GEOLOGIC FEATURES AND THEIR POTENTIAL EFFECTS ON CONTAMINANT MIGRATION, SANTA SUSANA FIELD LABORATORY

Howard G. Wilshire, Ph.D.

October 5, 2006

Disclaimer: This study was prepared for the Santa Susana Field Laboratory Advisory Panel, a project of the Tides Center. The work of the Panel was conducted under a contract with the California Environmental Protection Agency pursuant to funds provided by the California Legislature. The statements and conclusions in this report are those of the contractor and not necessarily those of the California Environmental Protection Agency. The mention of commercial products, their source, or their use in connection with material reported herein is not to be construed as actual or implied endorsement of such products.

Exhibit 1. Drawdown contours (in feet) from water extraction, 1954-1997 in the northeastern part of the SSFL. From L. P. Smith (Haley & Aldrich), Appendix B, Conceptual Site Model, Santa Susana Field Laboratory, Hydrogeology Summary Report (April 2000), Figure 1.9.

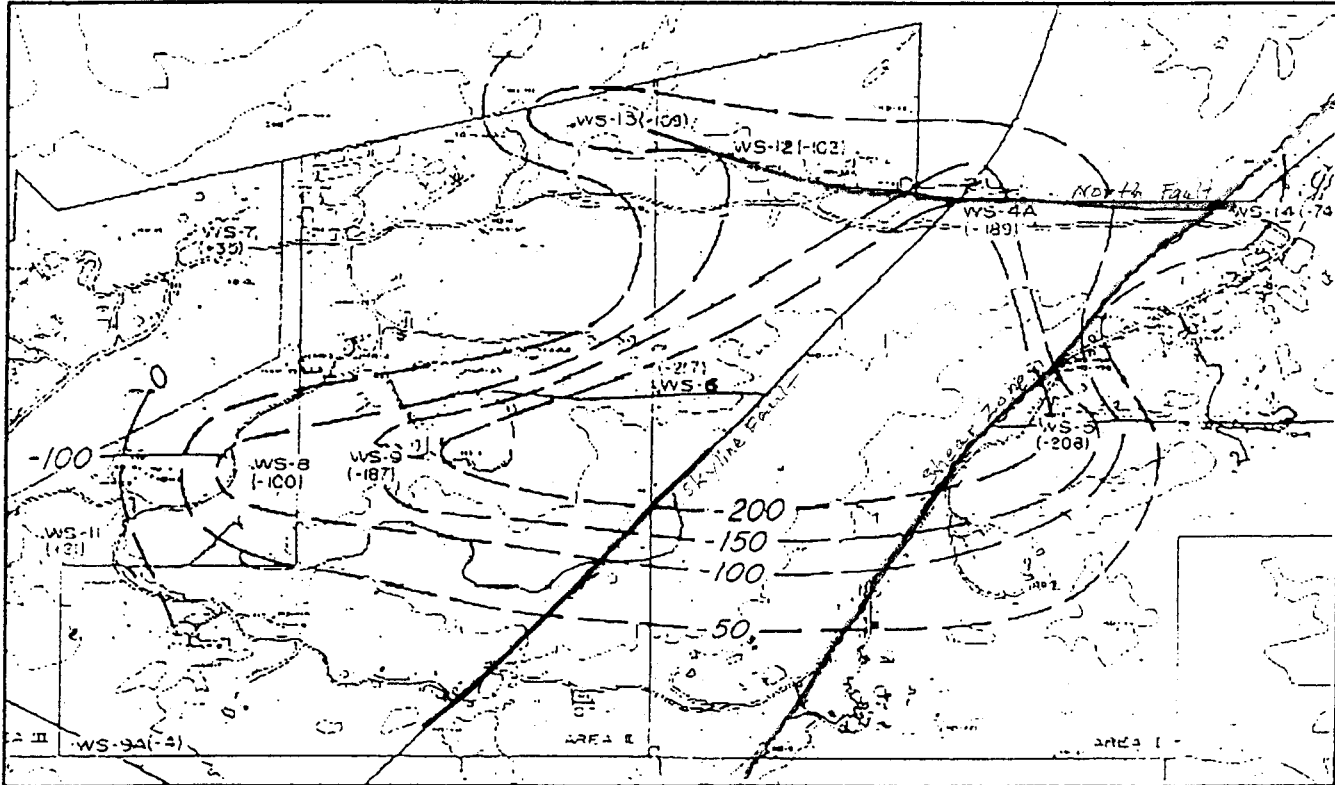
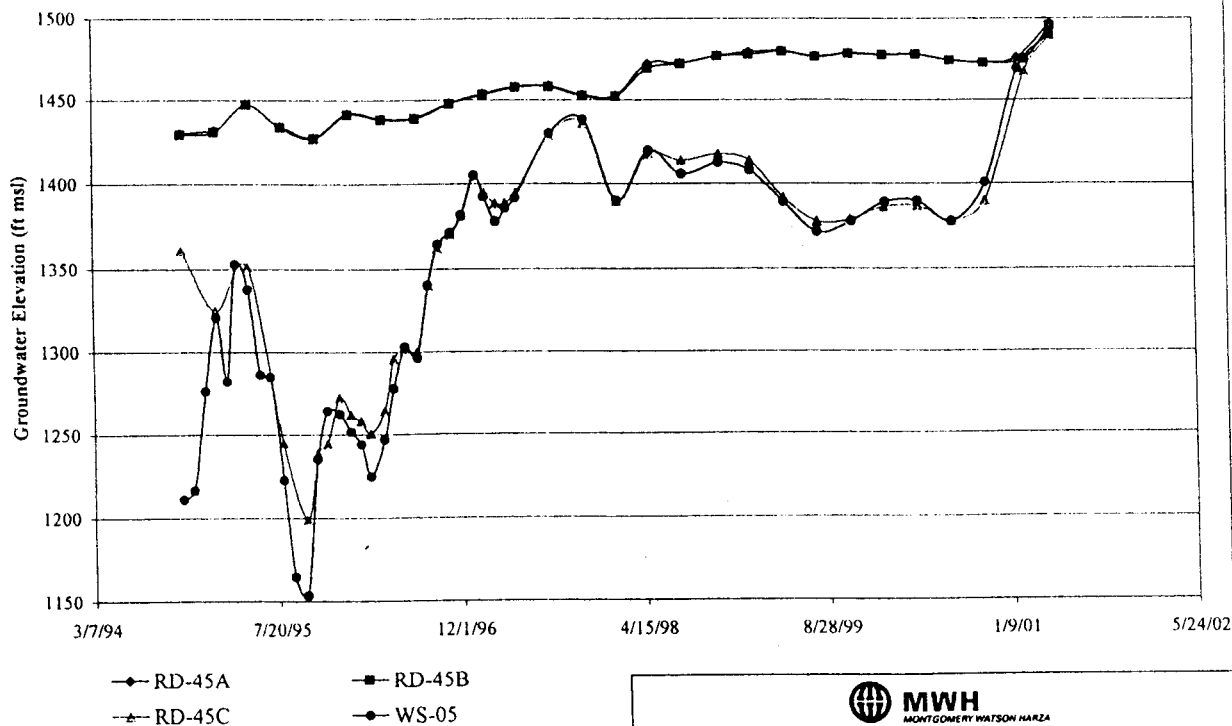
from the fault is not clear. Rates of response through the different kinds of fracture systems (clusters of steep fractures in the fault zone) and discontinuous, complex joint and stress fracture systems may cloud pump testing results. This is consistent with the behavior of wells WS-4A, WS-12, and WS-14 in the 1996 hydraulic communications study.⁷⁶ These wells did not respond immediately to shutdown of WS-6, but water levels in those wells (see Exhibit 3 for well locations) began to rise five to seven days later. This was true also of WS-13, but it could have been responding to RD-9 as well as WS-6. The drawdown pattern shown in Exhibit 1 also supports North Fault as a groundwater conduit.

Exhibit 2. Hydrographs, 1994-2001, for wells WS-5, RD-45A, RD-45B, and RD-45C. From MWH, Technical Memorandum, Geologic Characterization of the Eastern Portion of the Santa Susana Field Laboratory (February 2002), Figure 15. Note faults differ from current representations.

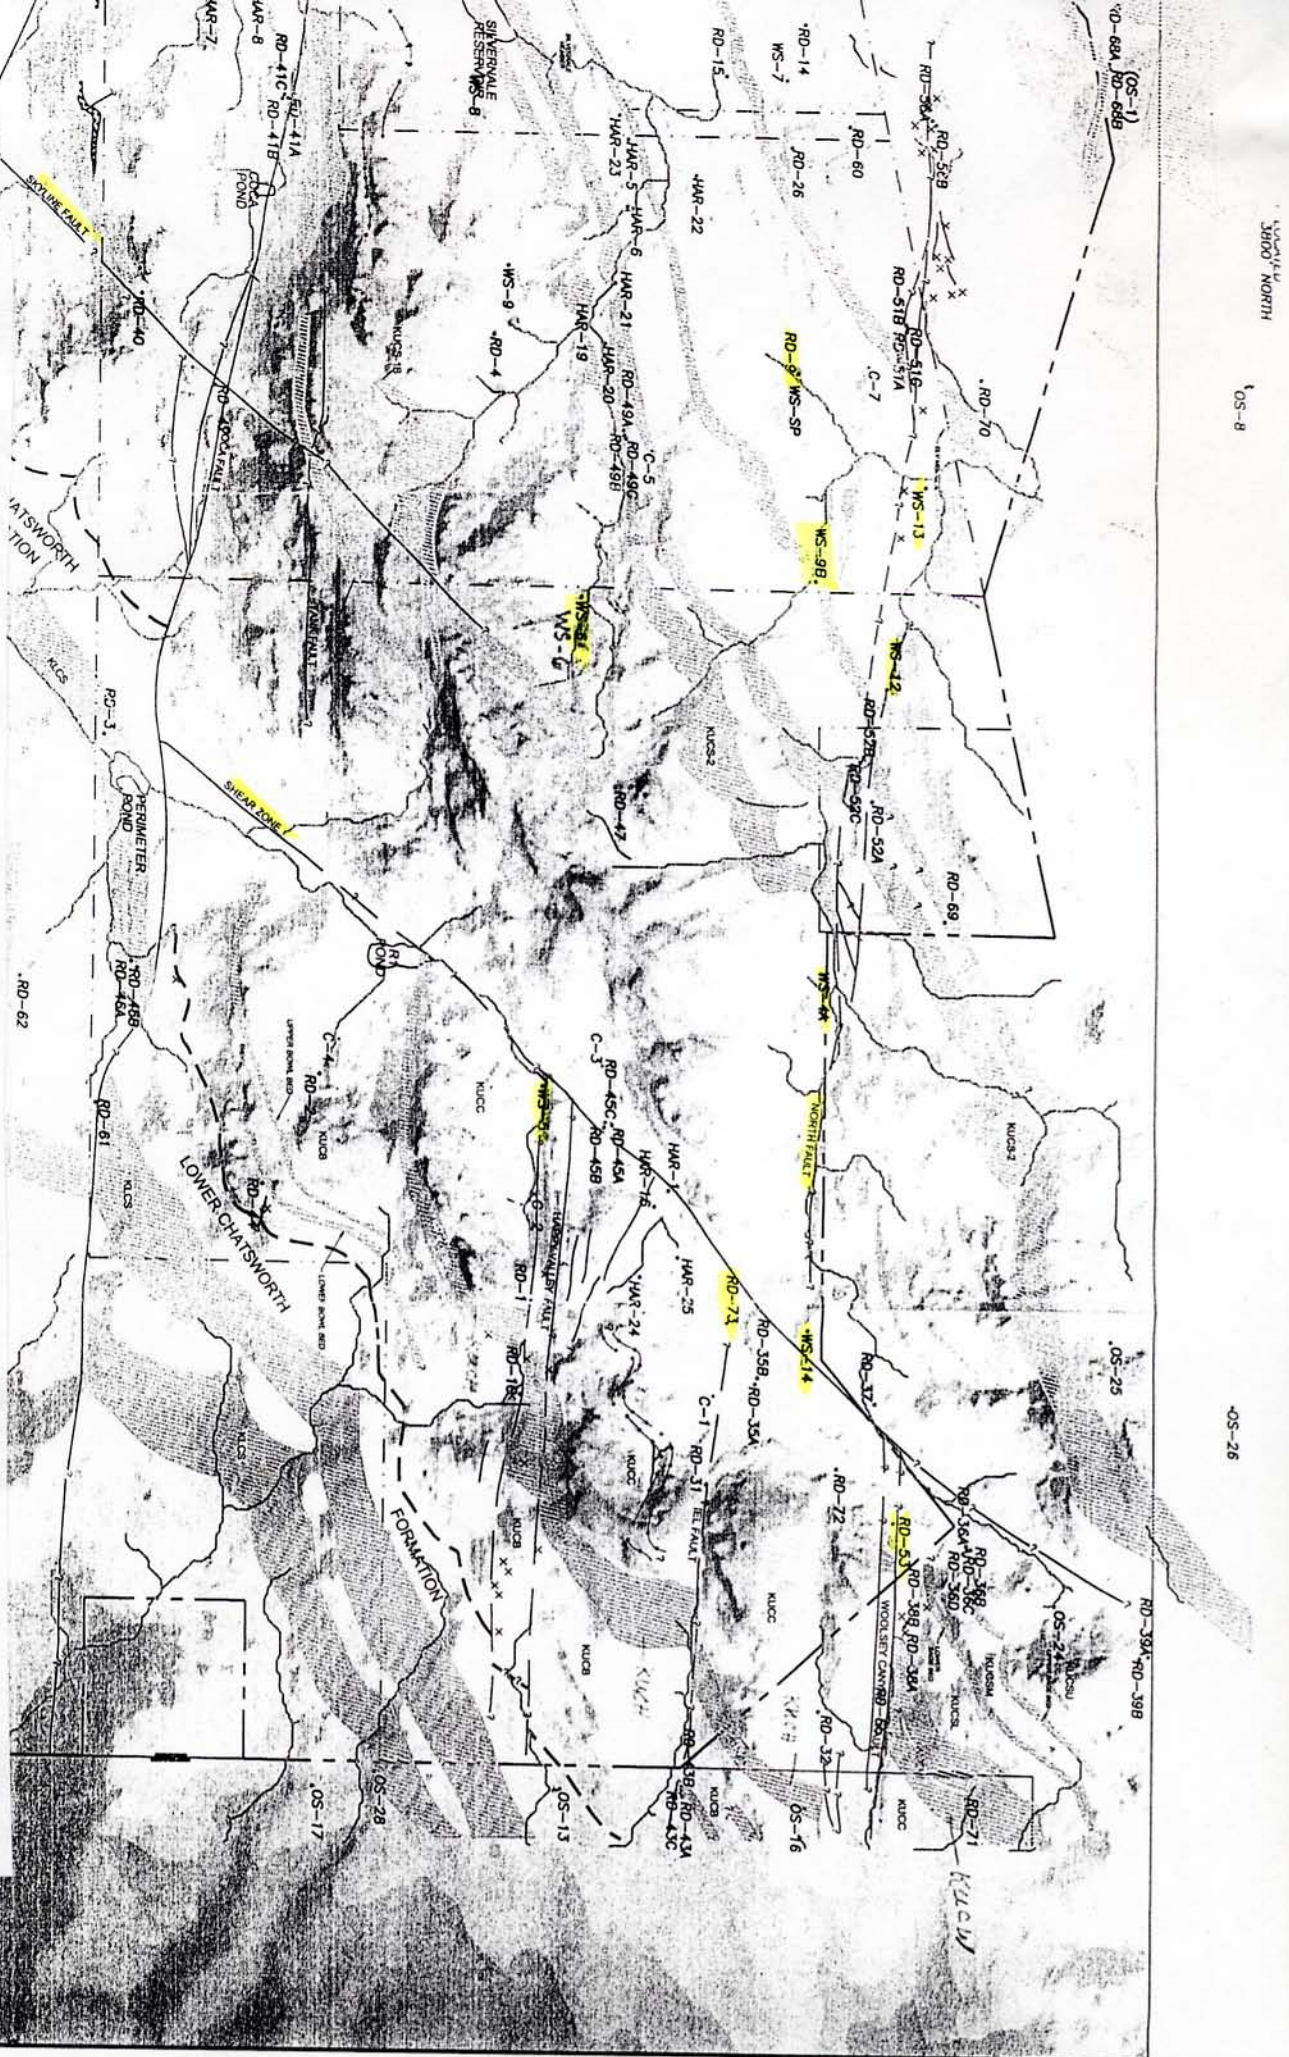
The RD-45 well cluster, now considered to be on the west side of the Shear Zone, shows an interesting response between 1994 and 2001 to shutdown and startup of pumping of well WS-5, on the east side of the Shear Zone. RD-45A is interpreted to be open from the Middle Sage Member across the Lower Line Bed into the Lower Sage Member, RD-45B is interpreted to be open only in the Lower Sage Member, and RD-45C is interpreted to be open within and below the Woolsey Member(?).⁶⁵ It should be noted that lithologic logs of these wells indicate that the Lower Line Bed is allowable in 45A and C, but not in B, and that identification of the Woolsey Member(?) is not allowable by the lithologic log of 45C, that is, the material logged at the appropriate depth in 45C does not resemble descriptions of the Woolsey Member. Other reports⁶⁶ identify this level of 45C as the Happy Valley Member, which also does not resemble the well log. Exhibit 2 shows the long-term hydrographs for wells WS-5 and the RD-45 cluster. RD-45C practically duplicates the water level pattern of WS-5, whereas RD-45A and B do not respond to shutdown or pumping of WS-5. It is noteworthy that shutdown of WS-5 in October

2000 resulted in a makeup of the 80 foot difference in water levels between RD-45A, B and RD-45C. Table 4 of the 1997 Hydraulic Communications report shows all three wells of the RD-45 cluster responding rapidly to well shutdown and restart, but hydrographs show that RD-45A and B are responding to well WS-6, whereas RD-45C is responding to well WS-5. This behavior is perplexing, but it is difficult to see how, at least at the screen level of RD-45C, the Shear Zone can be acting as an aquitard.

West of the Shear Zone, wells C3, RD-45A, and RD-45B are located within the Lower Sage Member, stratigraphically above the Woolsey Canyon Member. A section between 585 and 655 feet depth in RD-45C is tentatively interpreted to represent the Woolsey Canyon Member (note that this earlier was interpreted to represent the Happy Valley Member, but the log of RD-45C for that interval does not resemble descriptions of either the Woolsey Canyon or Happy Valley Members; identification of the Lower Sage Member in C3, RD-45A, and 45B also has difficulties because of uncertain location of the Lower Line Bed—see discussion of Shear Zone). The water level in RD-45C, thought to be open below the top of the Woolsey Canyon Member was at the time of the measurements about 80 feet lower than that of wells C3, RD-45A, and RD-45B.¹⁰⁴ As previously discussed, this difference was made up with the shutdown of WS-5 in 2000 (Exhibit 2).

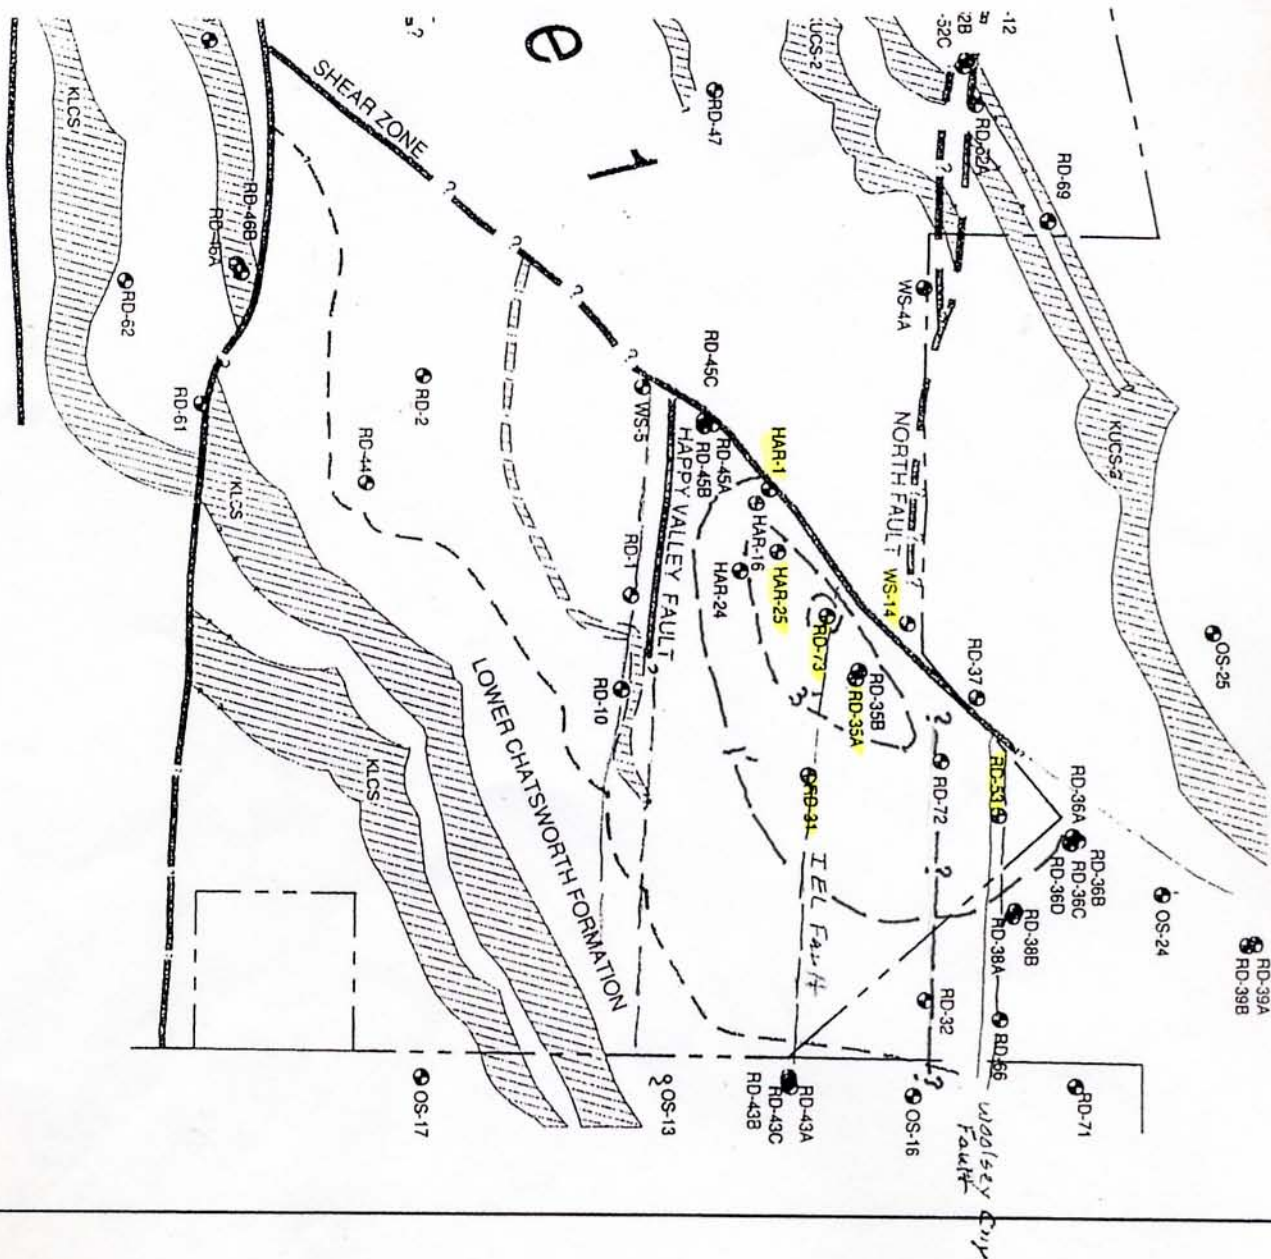
Contours representing drawdown from the RD-73 pump test are shown in Exhibit 4. The contours are interpreted to indicate an apparent rise in hydraulic conductivity about parallel to strike of the Chatsworth Formation, and that "drawdown appears to truncate at the shear zone to the west, and at the Happy Valley Fault to the south."⁷⁰ This is based solely on the behavior of WS-14 (discussed in the previous paragraph) because no other wells west of the Shear Zone were monitored, and there is no control for designating the relationship of drawdown to the Happy Valley Fault. Representation of the contours as crossing the subsequently recognized IEL and Woolsey Canyon Faults without deflection does not prove that they are not aquitards, but rather there is no control for the location of the contours—that has not changed since the contours were drawn or the faults were mapped. A possible E-W fault passes very close to RD-72 and RD-32 between the Woolsey Canyon and IEL faults.⁷¹ The presence of a fault in this area is supported by the video log of RD-32,⁷² which logs a number of broken zones; a log of RD-72 is not yet available.

72. Among the problems with this interpretation is the lack of information of where RD-72 may be located with respect to a possible fault in close proximity to RD-72 (see Exhibit 4). In addition, RD-72 has a history of sporadic TCE detects, at times showing no contamination.⁸⁰ As shown in Exhibit 4, drawdown contours for a pump test of RD-73, and in Exhibit 5, water level contours for Groundwater Unit 1a as recognized in 2000, the contours pay no attention to faults, including the Woolsey Canyon Fault Zone, the IEL Fault, and the possible fault near RE-72, not recognized at that time. However, no new data that would discredit the interpretations represented by the contours have been made available subsequently. Thus, the role of the Woolsey Canyon Fault Zone as an aquitard is putative.

Representations of drawdown contours from a pump test of RD-73 (Exhibit 4) and of water levels in Groundwater Unit 1a (Exhibit 5) do not show any effect of the then-unrecognized IEL Fault, but no new data have been provided to show the contours to be wrong.

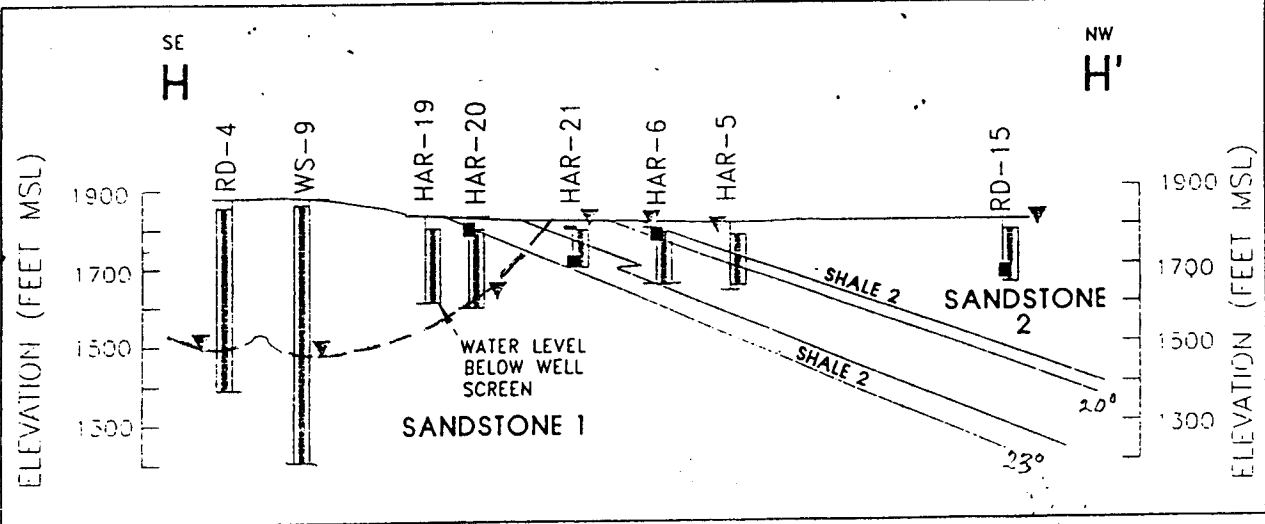
Exhibit 6 illustrates the case that Shale-2 acts as an aquitard between Sandstones-1 and -2 (old designations), as seen in water levels in wells RD-4, WS-9, HAR-19, and HAR-20 screened in Sandstone-1, and HAR-21, HAR-6, HAR-5, and RD-15 screened in Sandstone-2. Wells RD-4 and WS-9 are pumped wells with water levels governed by long-term extraction. Wells screened in Sandstone-2 are about 200 to 300 feet higher than those screened in Sandstone-1. It should be noted that the section in Exhibit 6 is viewed toward the south, contrary to normal practice.⁹⁵ The section does not position HAR-20 and HAR-21 consistently with the rather complex representation of Shale-2 in Fig. 2-9 of the Near-Surface Groundwater study. In addition, the well distribution is a shotgun pattern, but no information is given on how the wells were projected to the section line. It also is not clear why other wells in the area were not used to assess the water level differences—wells not used that might represent Sandstone-1 conditions include RD-49A, RD-49B, RD-49C, and C-5, and those that might represent Sandstone-2 conditions, but which were not used, include HAR-22, HAR-23, and RD-16.

An unassessed alternative to the interpretation that Shale-2 in this particular area is acting as an aquitard is shown by the dashed line drawn in on the section line of Exhibit 6. This is meant to indicate the possibility that the water levels in HAR-19 and HAR-20 are on the side of a drawdown cone produced by pumping of RD-4 and WS-9. The drawdown cone could intersect

the ground surface east of the wells screened in Sandstone-2 and thus not have affected their water levels.

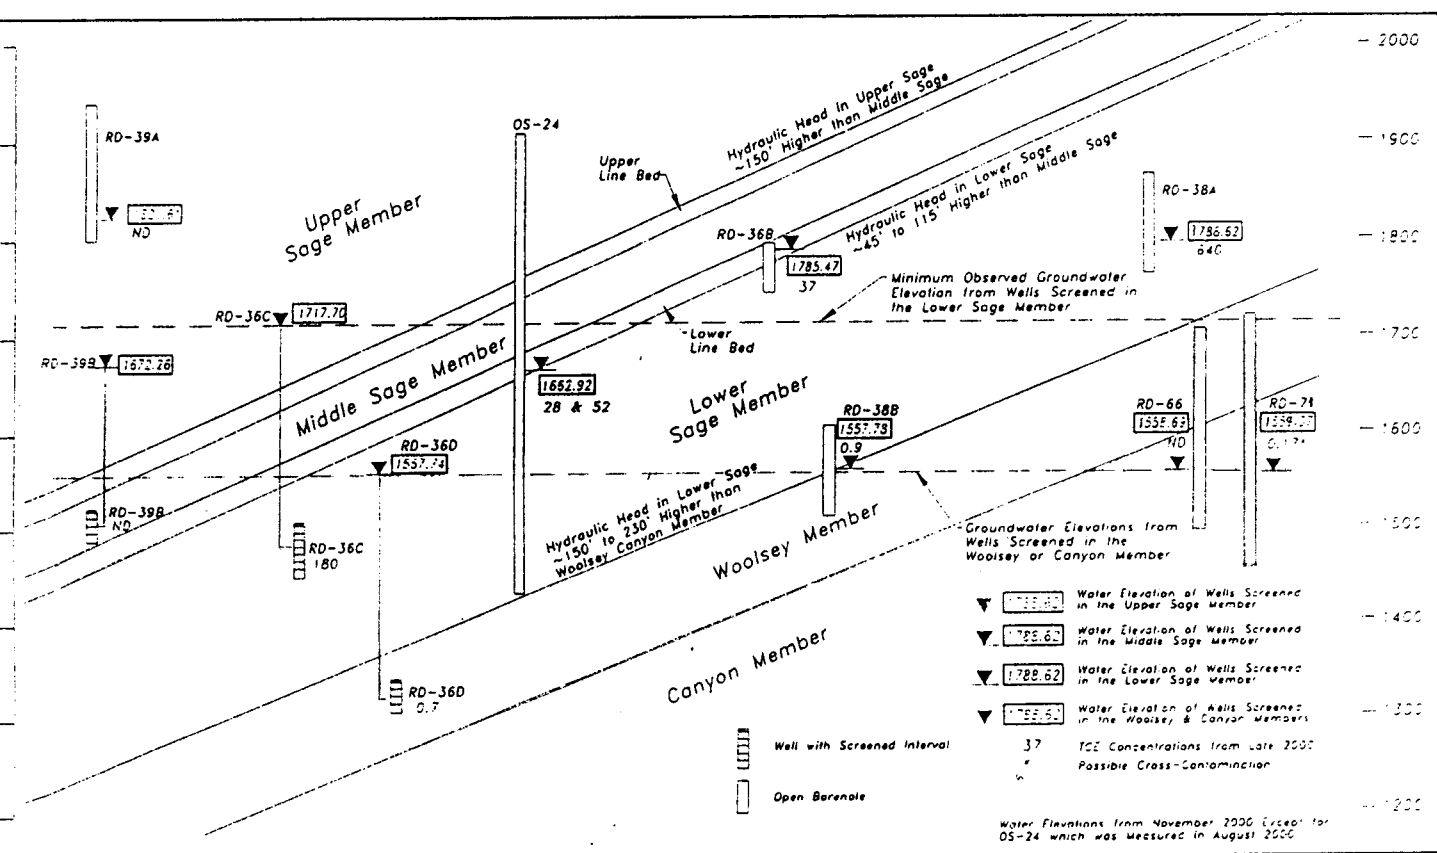
Support for the Upper Line Bed being an aquitard is found in the 150 foot difference in hydraulic head of RD-39A and RD-39B. RD-39A is screened solely in the Upper Sage Member and RD-39B solely in the Middle Sage Member. The Upper and Middle Sage Members are separated by the Upper Line Bed. A pump test of RD-39B did not affect the water level in RD-

39A, lending further support to the Upper Line Bed being an aquitard.¹⁰⁰ Since RD-39A is the only well screened solely in the Upper Sage, this provides only a very skimpy basis for assessing the broader role of the Upper Line Bed; moreover, there are only two wells, one periodically dry, screened solely in the Middle Sage (RD-39B and RD-36A). Because of the proximity of RD-39A and B to the Shear Zone, more confirmatory evidence is needed to assess the role of the Upper Line Bed. The pump test may or may not be significant, considering the similar behavior of RD-38A and RD-38B and the lack of tangible evidence of separation by an aquitard (described in connection with the Woolsey Canyon Fault Zone above), and the behavior of the Lower Line Bed described below.
